B. H. Whitley  
Director  
Regulatory Affairs

**Southern Nuclear Operating Company  
Vogtle Electric Generating Plant Units 3 and 4  
Request for License Amendment and Exemption:  
Shield Building Roof Changes (LAR-16-031)**

**Vogtle Electric Generating Plant (VEGP) Units 3 and 4**

**UFSAR Table 3H.5-9 (Sheet 2a of 3) Shield Building Roof Reinforcement Summary (Air Inlet) - Revise information as shown below.**

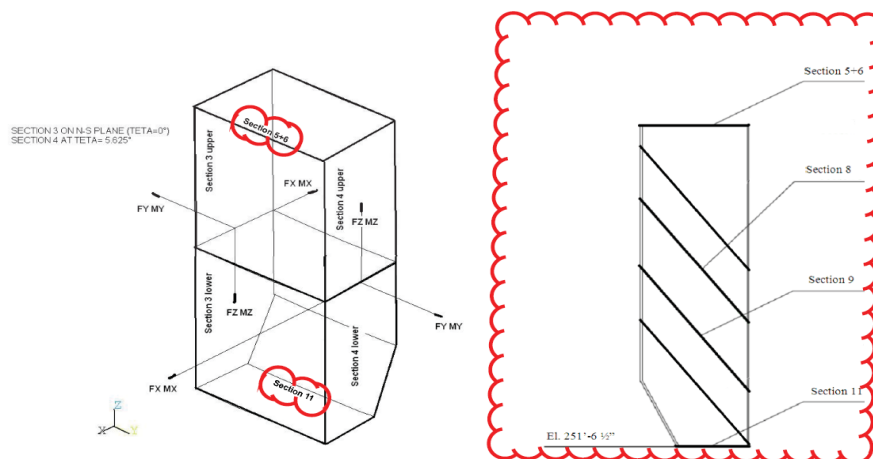
AIS Reinforcement Summary – Horizontal Sections						
Location (Figure 3H.5-11)		Steel Area (Vertical Direction – Z Local Dir.)				
		Required - Seismic Load Combinations (in <sup>2</sup> /ft)		Maximum Required <sup>(2)</sup> (in <sup>2</sup> /ft)	[Provided]*	[Design Limit <sup>(1)</sup> for Ratio Max Required/ Provided]*
Section	Angles	Seismic L/C	Values			
5+6	0°-5.625°	<del>16</del> 8	<del>1.65</del> 1.80	2.10 2.25	[Liner 1" = 12 (in <sup>2</sup> /ft) (Min.)]*	[0.1750.19 + 2%]*
	84.375°-90°	8	<del>1.41</del> 1.70			
8	0°-5.625°	16	<del>2.10</del> 2.25			
	84.375°-90°	8	<del>1.69</del> 2.02			
9	0°-5.625°	16	<del>2.10</del> 2.14			
	84.375°-90°	<del>8</del> 24	<del>1.68</del> 2.14			
11	0°-5.625°	16	<del>1.61</del> 1.66	1.61 1.66	[Liner <del>3/4</del> 1" = 912 (in <sup>2</sup> /ft) (Min.)]*	[0.180.14 + 2%]*
	84.375°-90°	24	<del>1.21</del> 1.46

**UFSAR Table 3H.5-9 (Sheet 2b of 3) Shield Building Roof Reinforcement Summary (Air Inlet) - Revise information as shown below (figure blow-up is shown on the following pages).**

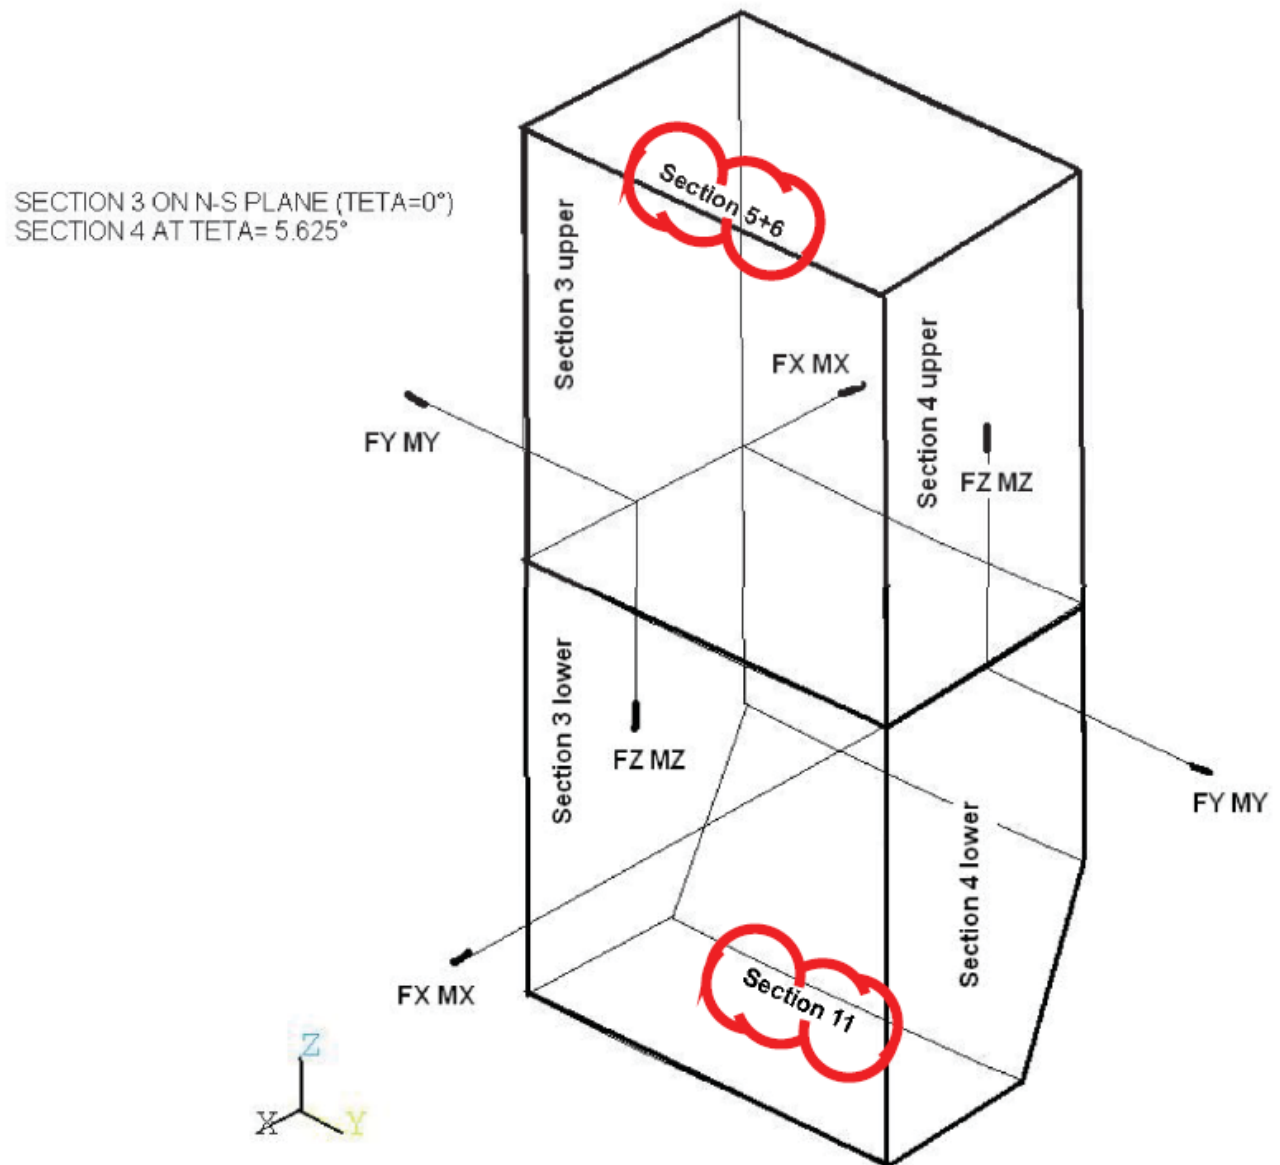
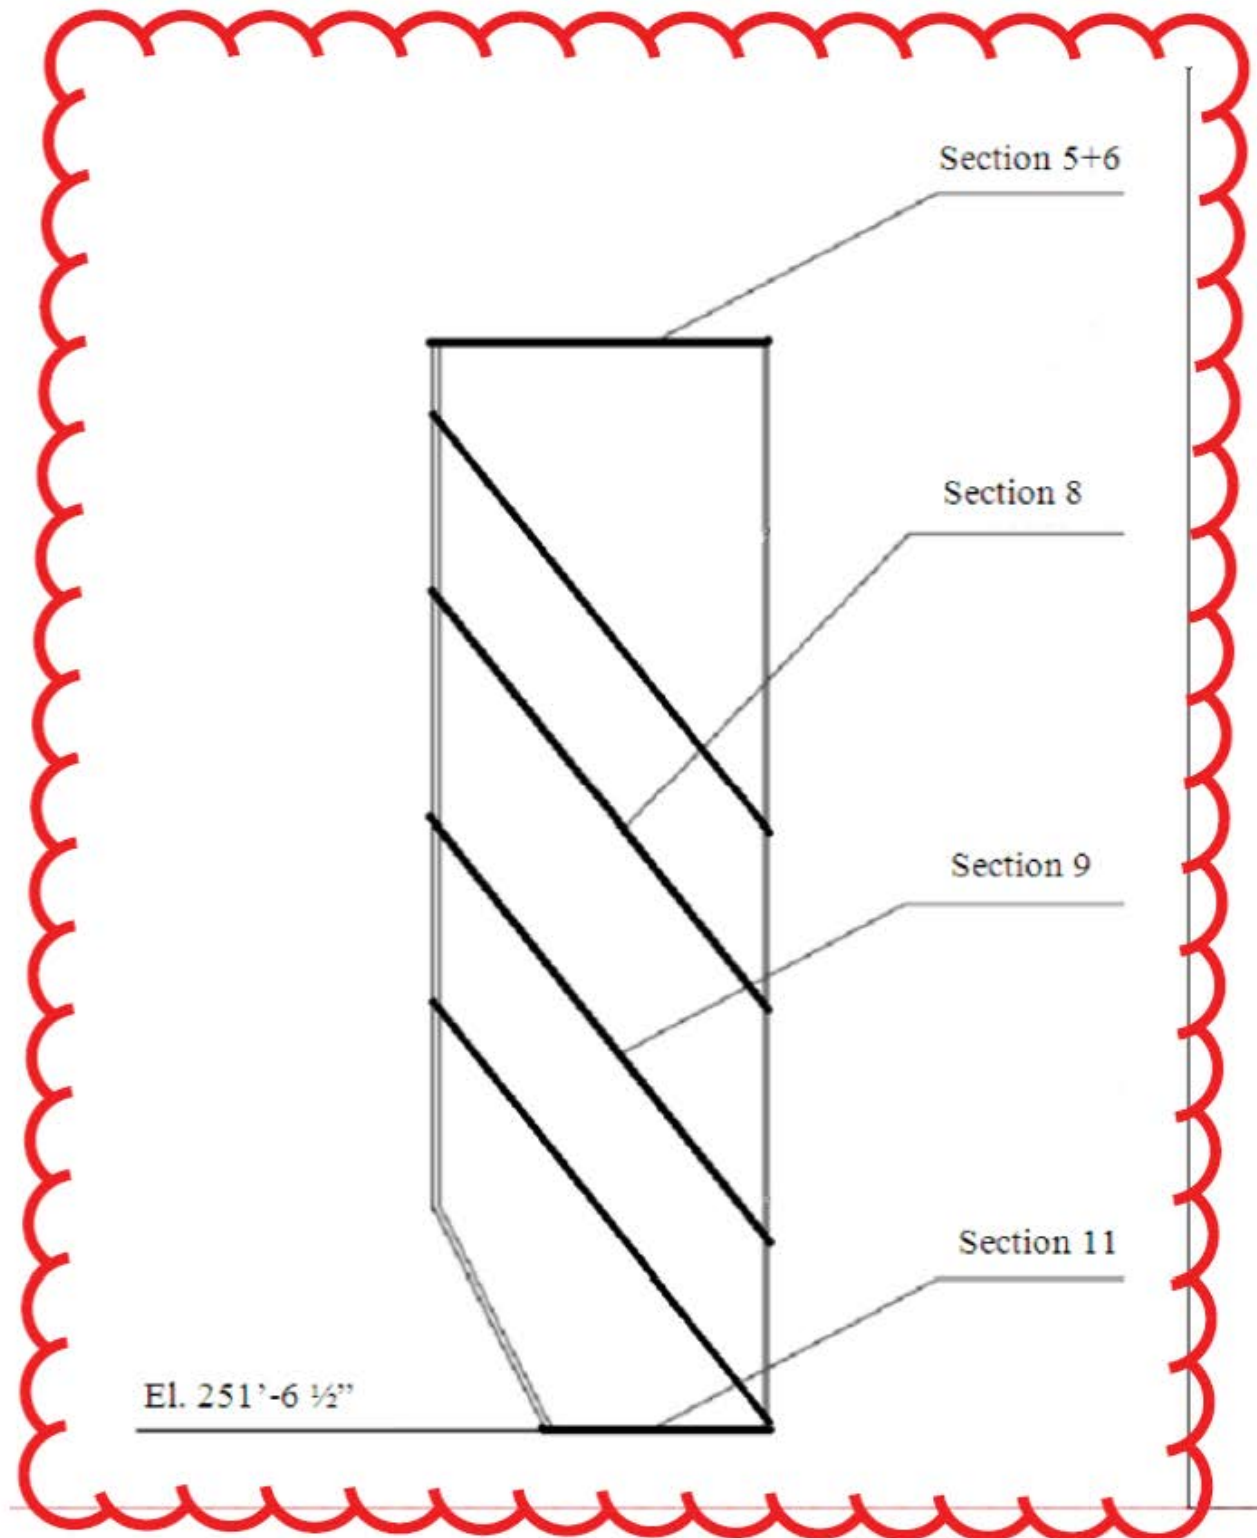
1. Revise values in table and the numbers of governing load combinations. CA#3
2. Remove dimensions from the locator figures. CA#4A
3. Add a legend to the table sketches to identify the location of the sections. CA#4A
4. The tie bar is renamed. CA#4D

AIS Reinforcement Summary – Vertical Sections						
Location (Figure 3H.5-11)		Steel Area (Hoop Direction – Y Local Dir.)				
Section	Angles	Required - Seismic Load Combinations (in <sup>2</sup> /ft)		Maximum Required <sup>(2)</sup> (in <sup>2</sup> /ft)	[Provided]*	[Design Limit <sup>(1)</sup> for Ratio Max Required/ Provided]*
		Seismic L/C	Values			
3 Upper	0	9	<del>9.56</del> <u>9.97</u>	<del>10.04</del> <u>10.53</u>	[Liner 1" = 12 (in <sup>2</sup> /ft) (Min.)*	[ <del>0.84</del> <u>0.88</u> + 2%]*
	90°	17	<del>8.32</del> <u>9.25</u>			
3 Lower	0	9	<del>8.14</del> <u>8.45</u>			
	90°	<del>18</del> <u>17</u>	<del>7.03</del> <u>7.75</u>			
4 Upper	5.625°	9	<del>10.04</del> <u>10.53</u>			
	84.375°	17	<del>8.69</del> <u>9.75</u>			
4 Lower	5.625°	<del>9</del> <u>10</u>	<del>7.98</del> <u>8.26</u>			
	84.375°	19	<del>6.82</del> <u>7.54</u>
